MFN 06-274

Subject: Response to RAI Letter Number 20 Related to ESBWR Design Certification Application – Seismic Design – RAI Numbers 3.7-16, 3.7-24, 3.7-27, 3.7-30, 3.7-32, 3.7-33, 3.7-35, 3.7-37, 3.7-38, 3.7-39, 3.7-50, 3.7-54 and 3.7-57

**Response to NRC RAI Letter No. 20 Related to ESBWR Design
Certification Application**

**RAI Numbers 3.7-16, 3.7-24, 3.7-27, 3.7-30, 3.7-32, 3.7-33,
3.7-35, 3.7-37, 3.7-38, 3.7-39, 3.7-50, 3.7-54, and 3.7-57**

Figure 7.6-1 Floor Response Spectra - CB Top X

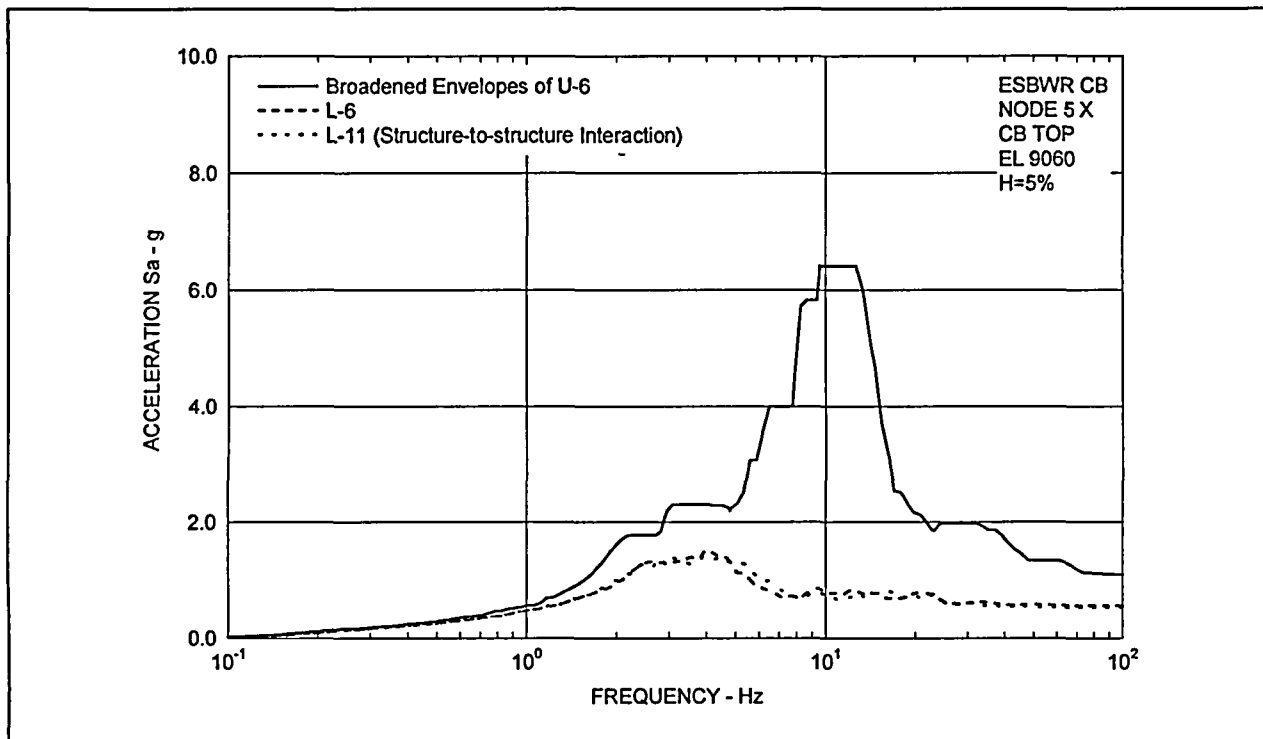
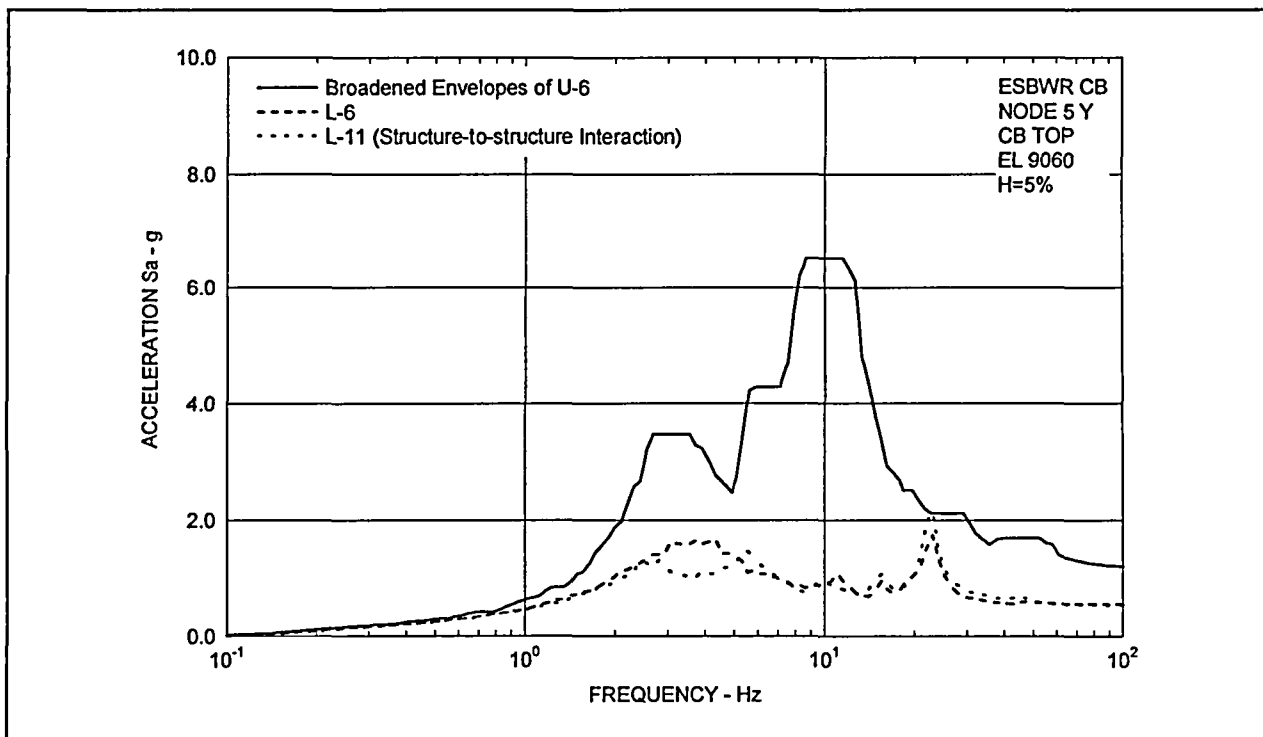
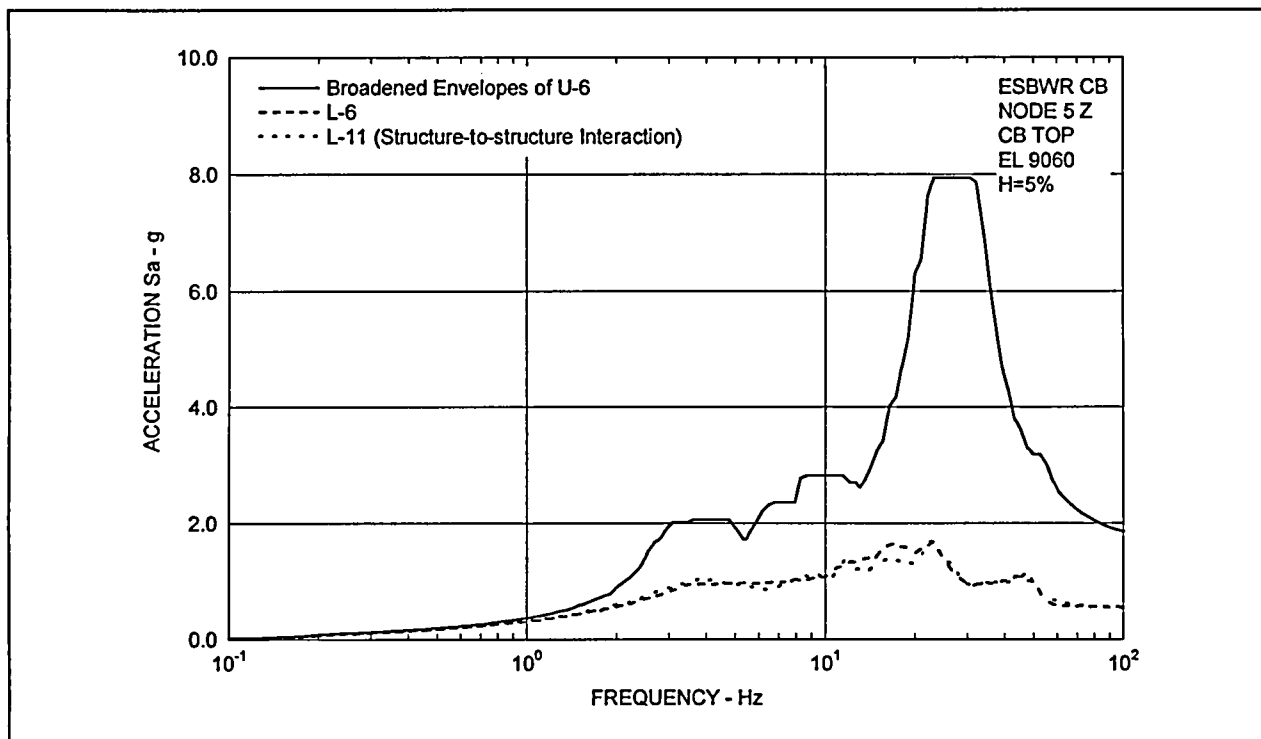
For the SSI analyses that were performed, the staff requests the applicant to describe in detail in the DCD how it considered the effect of structure-to-structure interaction through the soil between the RB/FB and CB. The staff considers this a potentially significant effect, especially for the response of the CB.

Comparisons of floor response spectra (FRS) (5% damping) at the top of CB are shown in Figures 7.6-1 through 7.6-3. The broadened envelope results of Case U-6 (uniform site, single envelope input motion case) are also shown in the figures for comparison.

It is found from the results that the effect of structure-to-structure interaction is the largest in the Y direction (East-West) FRSs, however, both FRSs without and with structure-to-structure interaction effect are bounded by the broadened envelope responses of uniform site cases in the whole frequency range.

As stated in Section 7.1, the existing DCD design load will be updated to incorporate the responses due to the single envelope input motion at the uniform sites. The revised DCD design load has no impact from the effect of structure-to-structure interaction.
